GOVERNMENT OF BERMUDA
Ministry of Public Works and Environment
Department of Works and Engineering

Ref: 41-113-120 Retaining Wall Reconstruction South Rd Smiths

This Addendum #1 contains (3) pages including this front page.

Approx. fence alignment

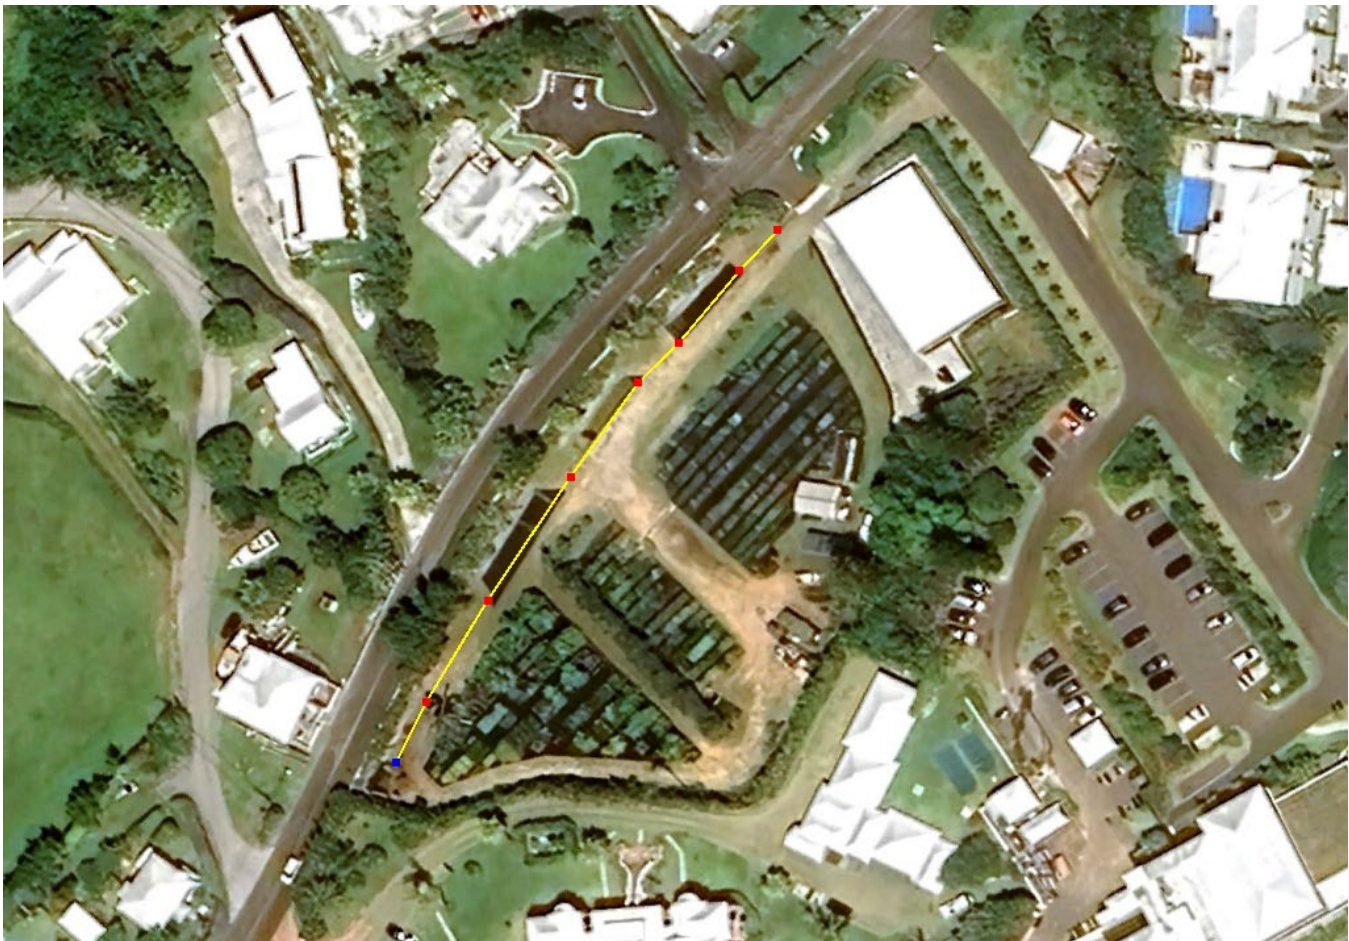
- Boundary Fence: Contractors should allow for the installation of a 315ft long 6ft chainlink fence (or similar) to separate the work site from the nursery operations. A minimum of 10ft access road to the nursery grounds should be maintained at all times. The contractor is not to store materials, tools etc on the nursery grounds. All waste must be disposed of off site; dumpsters belonging to the nursery and hotel may not be used.
